Subject: Response to Preliminary Design Issues
Albion-Sheridan Township Landfill
Albion, Michigan
Project No. 6E13045

Woodward-Clyde Consultants (WCC) is submitting this letter in response to the technical issues associated with the Preliminary (30%) Design for the Albion-Sheridan Township Landfill (ASTL). The issues described below were discussed during the February 4, 1997 meeting between Cooper Industries and Corning, Inc. (The Group), the United States Environmental Protection Agency (U.S. EPA), the Michigan Department of Environmental Quality (MDEQ), the U.S. EPA's contractor (Earth Tech) and WCC.

Determination of Saturated Cover Depth Due to Stormwater Inflow

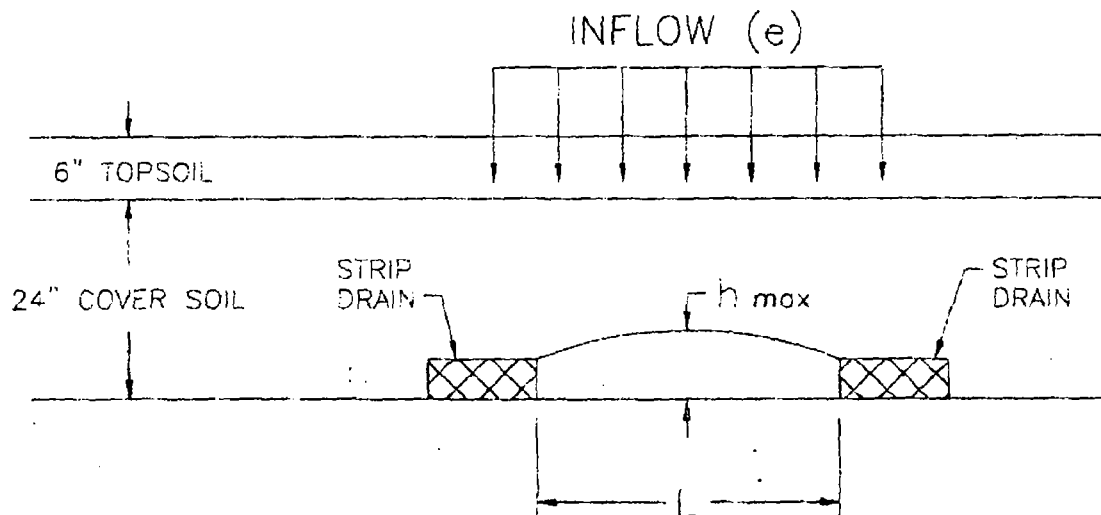
2. The drain layer technical equivalent incorporated the use of on-site soils and a synthetic strip drain configuration. The spacing criteria and basis for the strip drains in the cover system was not clearly supported in the 30% Design Document.

WCC concludes the proposed cover system utilizing the on-site soils ($K = 1 \times 10^{-4}$ cm/s) in conjunction with the 12 inch wide strip drains spaced 20 feet apart exceeds the subsurface drainage requirements for slope stability of the landfill cover system. The factor of safety to an increased inflow is the additional 9 to 10 inches of distance from the modeled height of saturated cover materials (20.4 inches total height) to the surface of the cover system (30 inches total height). This conclusion is based on the HELP Model run performed for the proposed design cover system and the saturated cover depth calculations supporting the spacing of the strip drains and their effect on the saturated cover depth.

If h_{max} is less than the depth of the landfill cover above the FML, then the design is acceptable, if not, then redesign the stripdrain spacing
